CITY OF ALBUQUERQUE

RE: Valle Prado Unit 1
Grading and Drainage Certification
Engineers Stamp Date 11/19/14 (C09D011)
Certification Date 4/23/15

Re: Grading and Drainage Certification, Valle Prado Unit 1
DRB Case No. 1004404, (C09/D011)

CITY OF ALBUQUERQUE PUBLIC WORKS DEPARTMENT			
VALLE PRADO UNIT 1 GRADING AND DRAINAGE PLAN			
Design Review Committee	City Engineer Approval	Mo./Day/Yr.	Mo./Day/Yr.
City Project No.	Zone Map No.	Sheet	Of
XXXXXX	C-09-Z	1	2

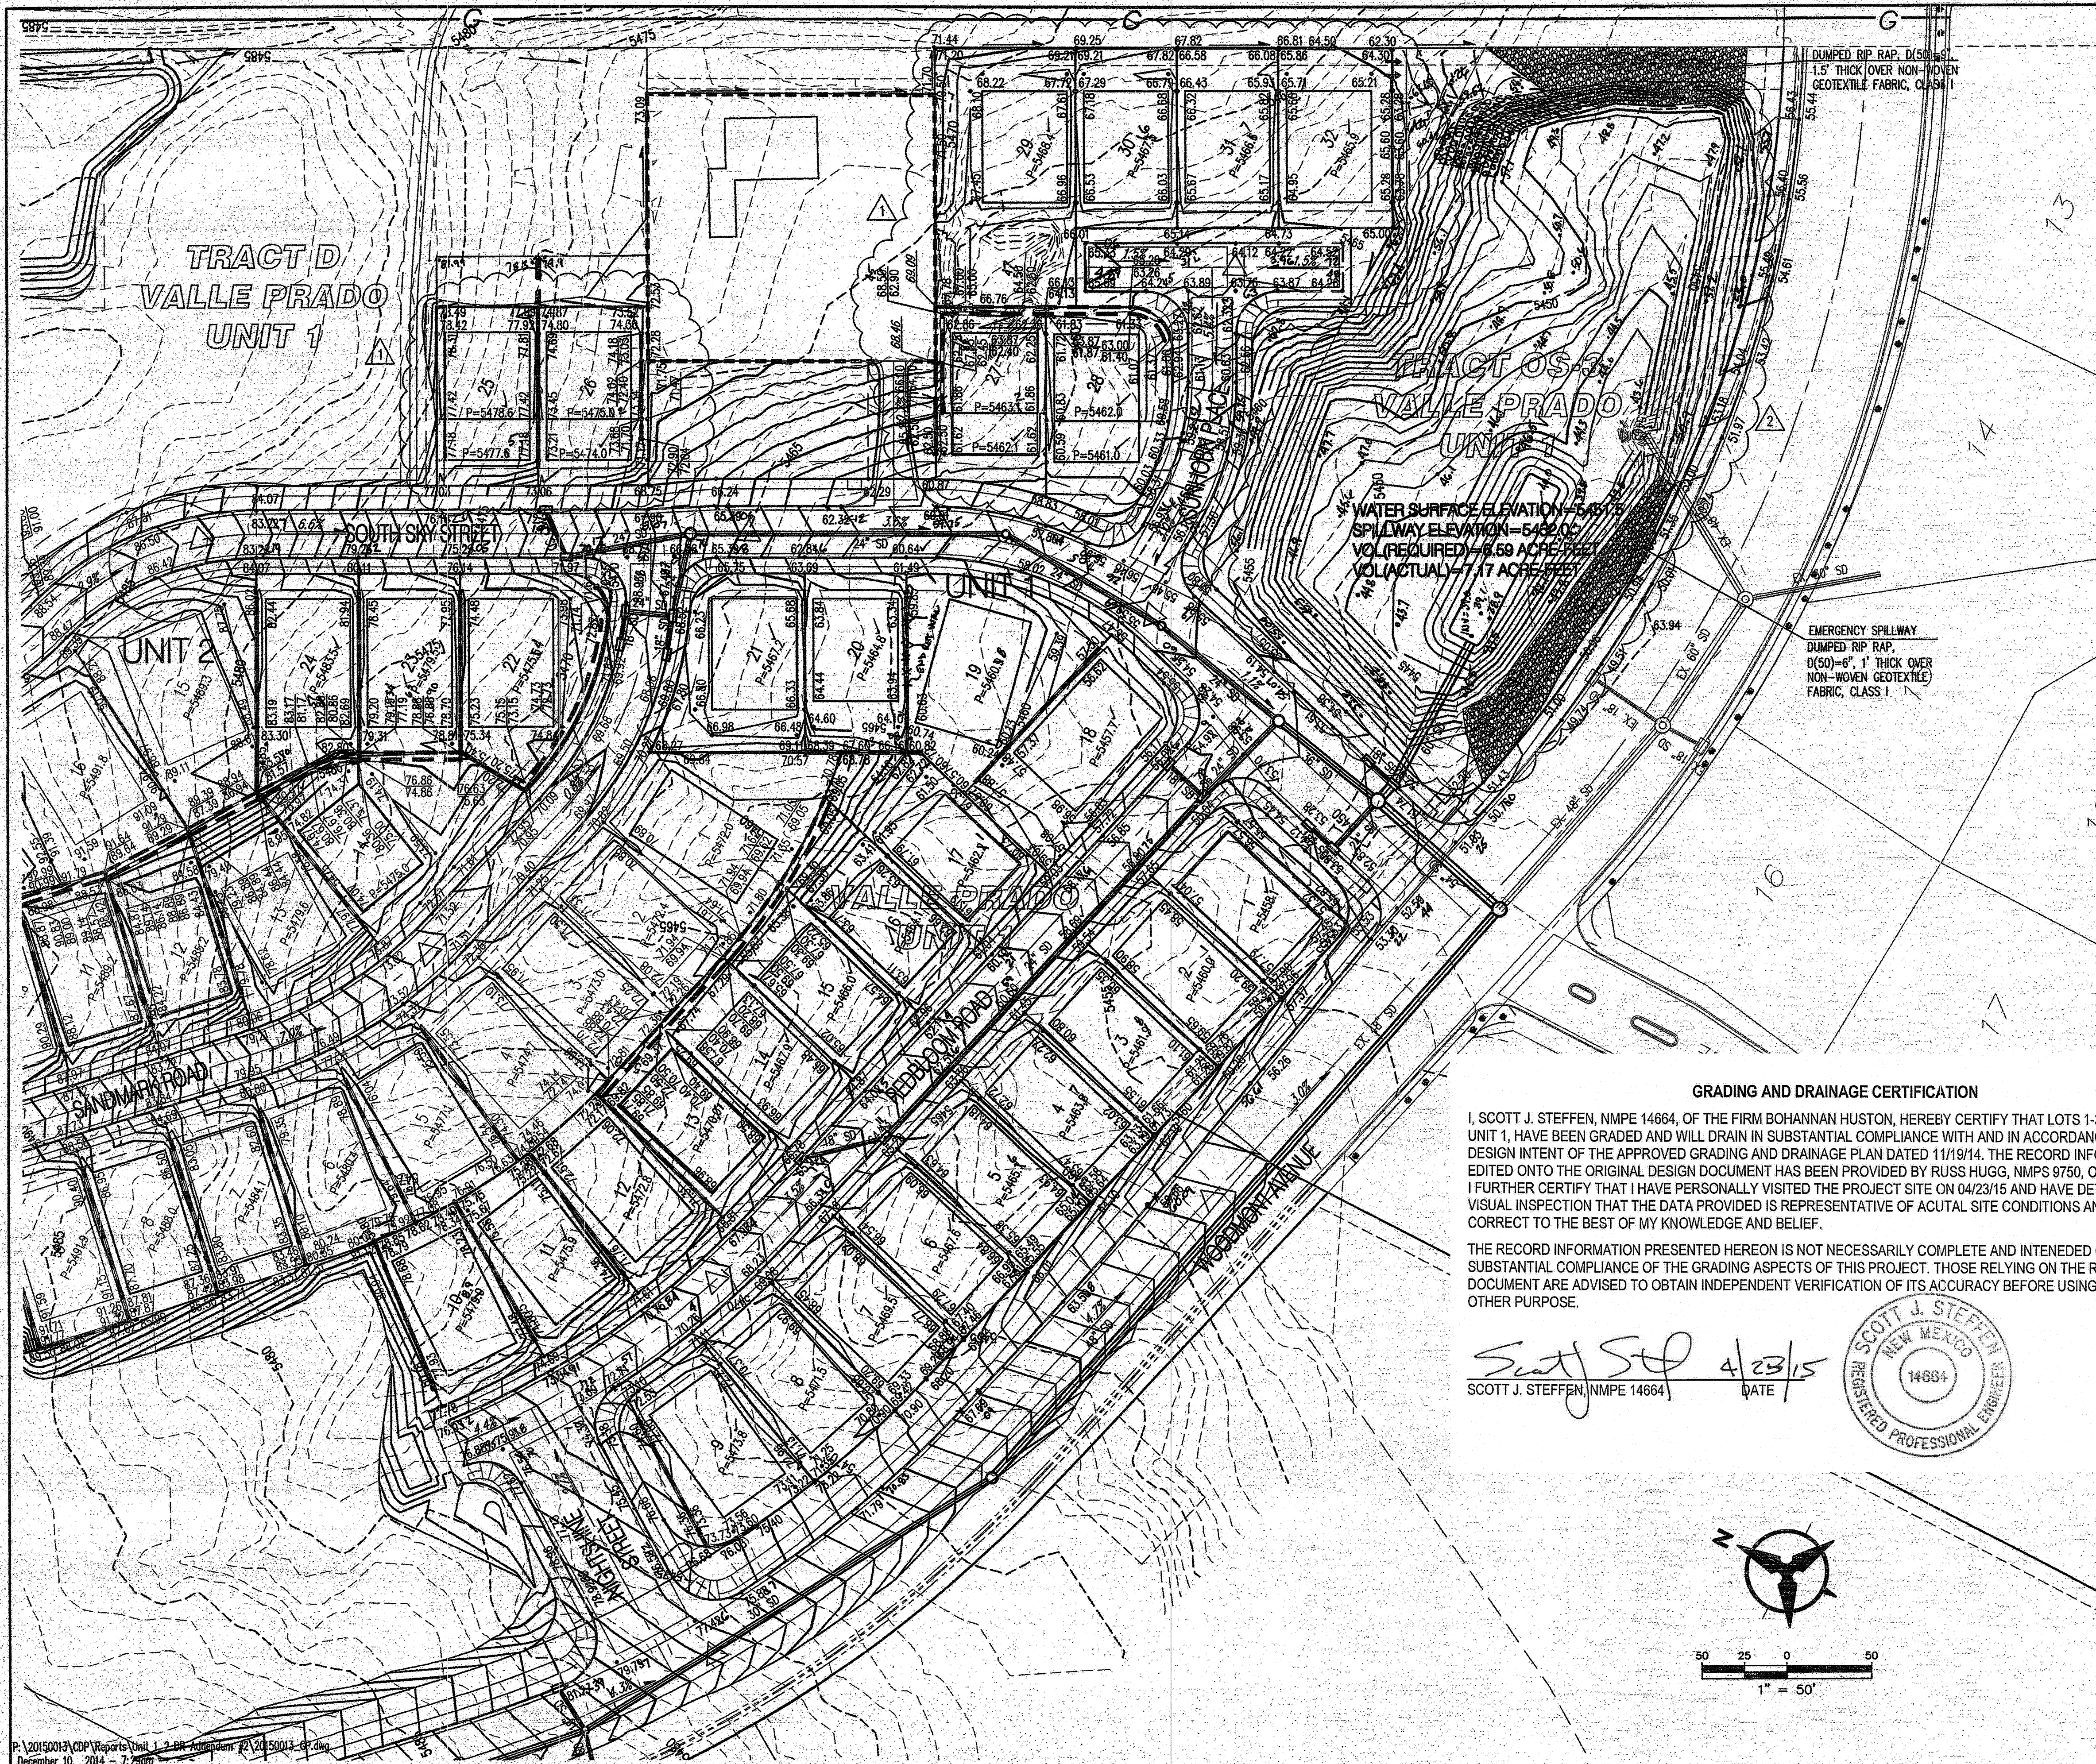
The final certification was originally submitted to City Hydrology on February 24, 2015. Curtis Cherne provided a comment per the attached email, dated February 27, 2015, regarding the Pond E rip-rap. In response to the comment, additional rip-rap, along with a swale directing water from the gas easement to Pond E, have been constructed and are shown on the as-built grading plan.

Looks like drainage coming down the gas easement road is going to turn into Pond E, north the rock. You're going to get a cut here.
